LEE'S SUMMIT
MISSOURI
Development Services Department

Development Services Staff Report

File Number	PL2025-052
File Name	Preliminary Development Plan – TODCO Beverages
Applicant	Engineering Solutions
Property Address	1270 SE Century Dr.
Planning Commission Date	July 10, 2025
Heard by	Planning Commission and City Council
Analyst	Claire Byers, Senior Planner

Figure 4 – Architectural Elevations

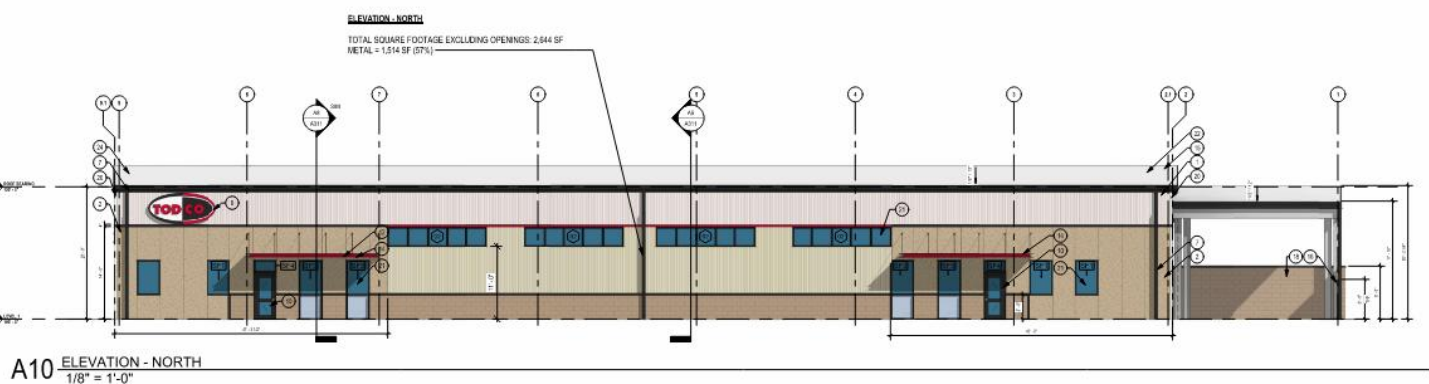
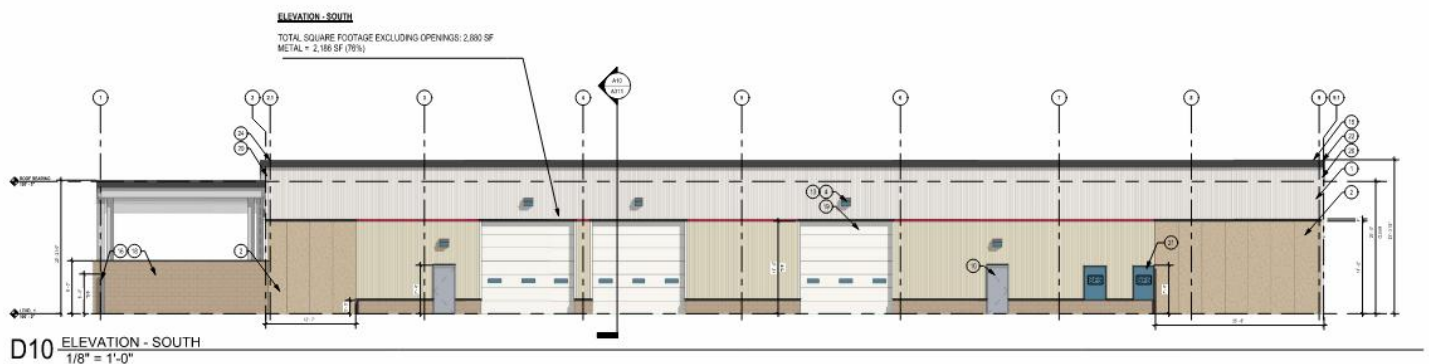
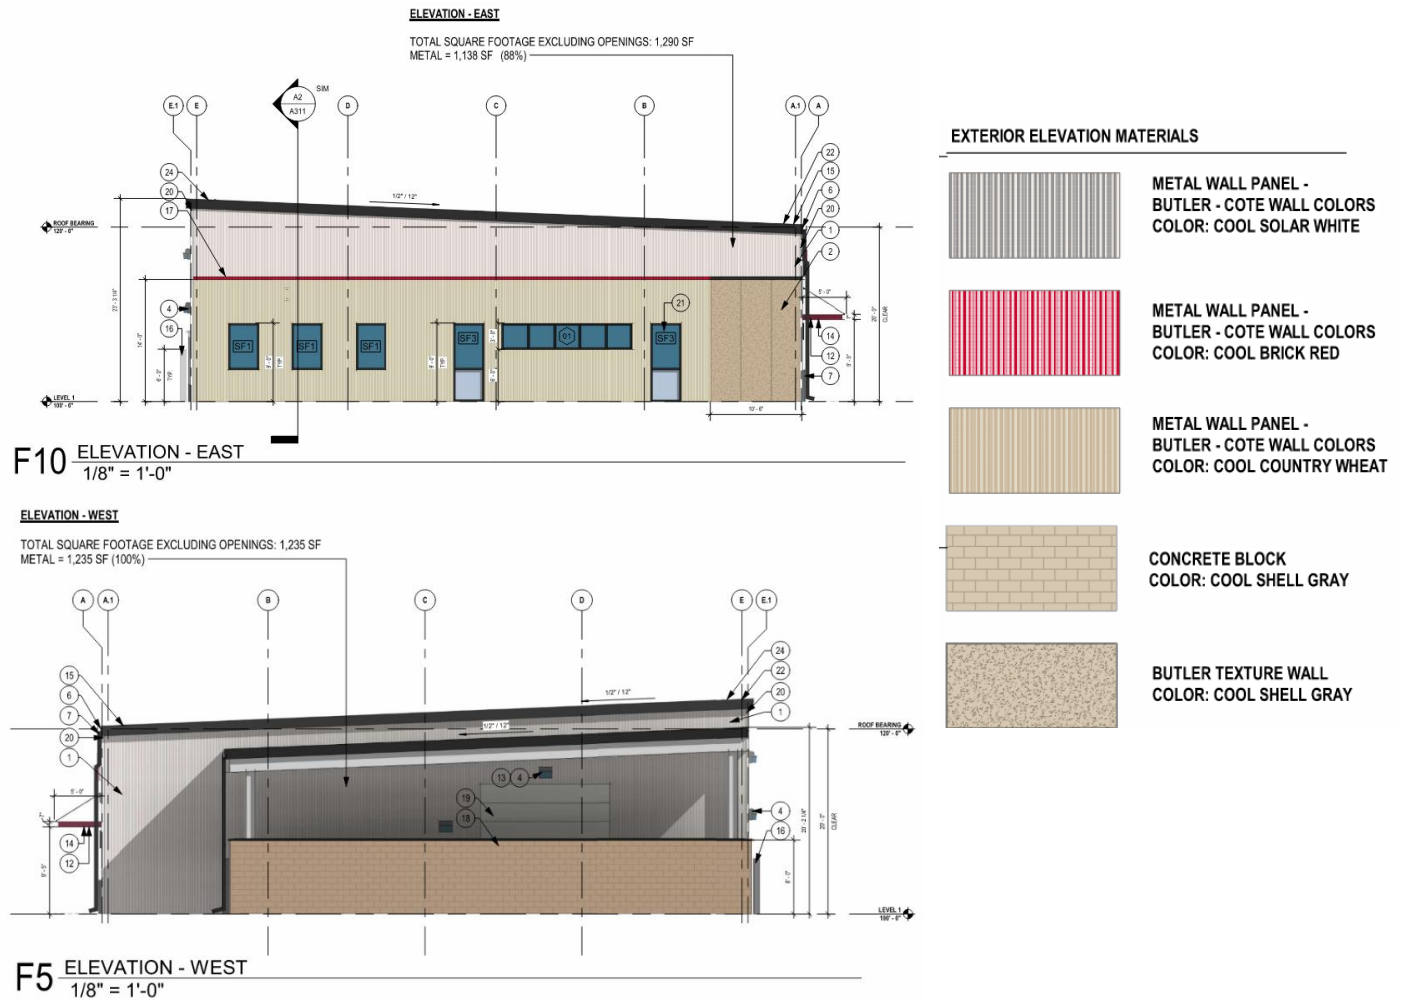
1. The applicant is seeking a modification to UDO Section 8.170 pertaining to the permitted building materials for industrial buildings. Staff has reviewed the request and supports the modification for the reasons identified below.

- **Required-** Metal may not exceed 40% of any façade. A modification for the use of metal up to 75% of any façade may be approved by the Planning Commission. A modification for the use of metal to exceed 75% of any façade may be approved by the Governing Body.

- **Proposed-** The applicant has proposed exterior elevations that exceed the 40% maximum usage of metal allowable by right.
 - North elevation- 57% metal proposed

- East elevation- 88% metal proposed
 - South elevation- 76% metal proposed
 - West elevation- 100% metal proposed
- **Recommendation-** The subject property was previously within the Metal-Building Overlay, which would have allowed the proposed metal façade as shown without requiring a Preliminary Development Plan modification request. In contrast, neighboring industrial buildings were developed with minimal architectural requirements, such as metal panel systems with only one color, and no architectural variations. Additionally, the proposed building is oriented towards the north of the site near the private drive, instead of along the SE Bailey Dr. frontage. The view from the ROW would be primarily of landscaping as well as a 6' tall privacy fence to provide a visual buffer from the rear accessory outdoor storage.

1. A modification shall be granted to the maximum allowable 40% use of metal on any façade, to allow the following percentages of metal on the respective facades: 57% on the north elevation; 88% on the east elevation; 76% on the south elevation; and 100% on the west elevation.
2. The development shall occur in accordance with the Preliminary Development Plan dated June 13, 2025.
